UNITED STATES PATENT AND TRADEMARK OFFICE

10/626,805

| Office Action Summary | Application No. 10/626,805 | Applicant(s) THOMPSON, RONALD D. | |

DETAILED ACTION

4,616,968

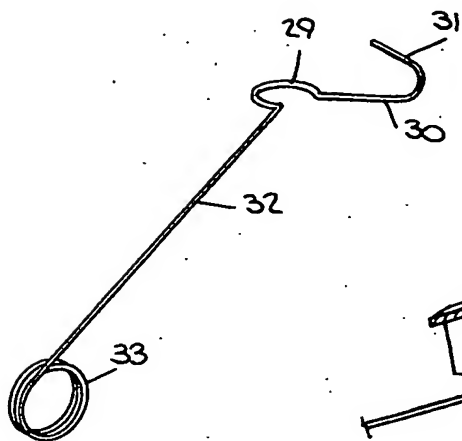
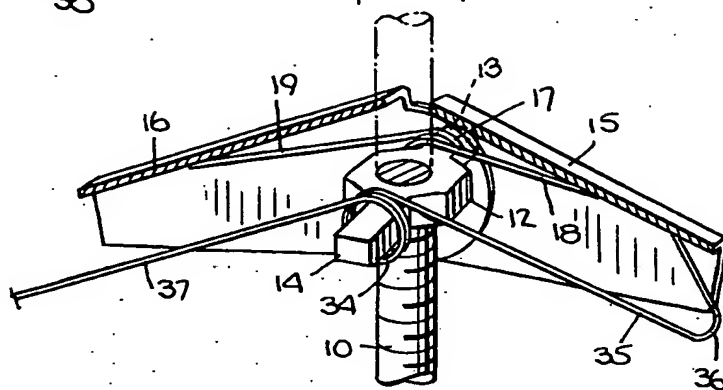
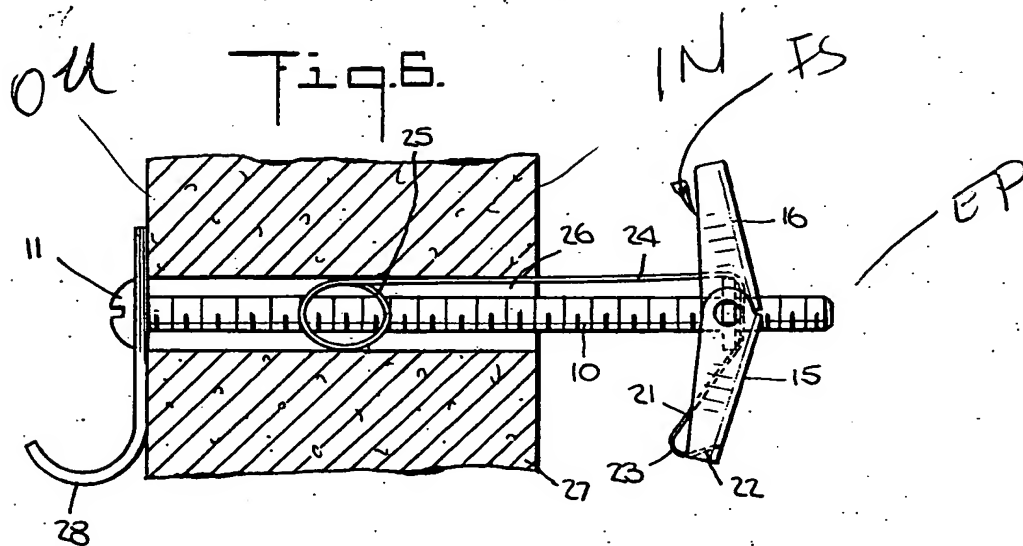
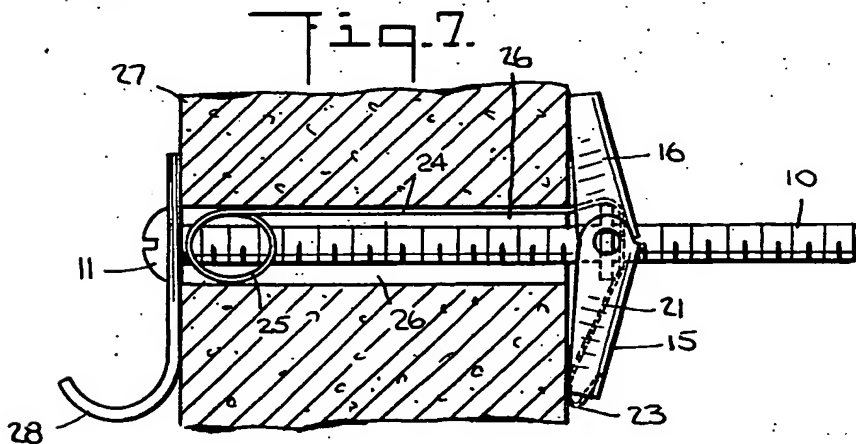
Claims 1-8 are rejected under 35 U.S.C. 103(a) as being unpatentable over US Patent #4,616,968 to GIANNUZZI in view of US Patent #5,875,606 to JENSEN and US Patent #4,298,298 to PONTONE. Regarding claims 1,4 and 7, GIANNUZZI discloses the use of an anchor bolt assembly including a masonry block (27), a bolt (10) consisting of an elongated portion having external threads (column 4, line 1) and an end portion (EP) positioned in a hollow core of a masonry block (27) and extending outwardly thereof; a toggle member (15,16) positionable along the elongate portion of the bolt (10) wherein the toggle member (15,16) has a front surface (FS) engageable with an interior (IN) of the hollow masonry core (see figure 7 and the marked attachment). GIANNUZZI discloses the basic claimed anchor bolt assembly except for the bolt having an arcuate end and except for the inclusion of a nut. JENSEN teaches that it is known in the art to provide a toggle bolt assembly (1) wherein the bolt (2) has

an arcuate end portion (3) positioned perpendicularly to the wall (18,19). PONTONE teaches that it is known in the art to provide an anchor bolt assembly with nuts (26). It would have been obvious to one having ordinary skill in the art at the time the invention was made to provide the anchor bolt assembly of GIANNUZZI with an arcuate end, as taught by JENSEN, and a nut (26), as taught by PONTONE in order to provide the assembly with an ease for insertion in the opening disposed within masonry member while also rigidly retaining the bolt therein. The use of an arcuate member and nut holds the device in position relative to the masonry wall. Once inserted in to the wall, and prior to compressing the toggle bolt, the elongate member is just positioned within the hole; however, the inclusion of the arcuate portion and nut, stabilizes the bolt with regards to the masonry unit thereby preventing the elongate member from leaving the hole and thereby leading to a more accurately positioned bolt system. Regarding claims 2,5 and 7, the assembly of GIANNUZZI, as modified by JENSEN and PONTONE, includes a washer (76,84, as taught by PONTONE and a ledger (28) attachable to the masonry unit (27). Regarding claims 3,6 and 8, GIANNUZZI, as modified by JENSEN and PONTONE, teaches the use of a plurality of toggle members (15,16), wherein the toggle member (15,16) moves towards one another when moved to a compressed position, such that the toggle members (15,16) themselves move away from the modification of the arcuate end member (3) of JENSEN when the system is being compressed.
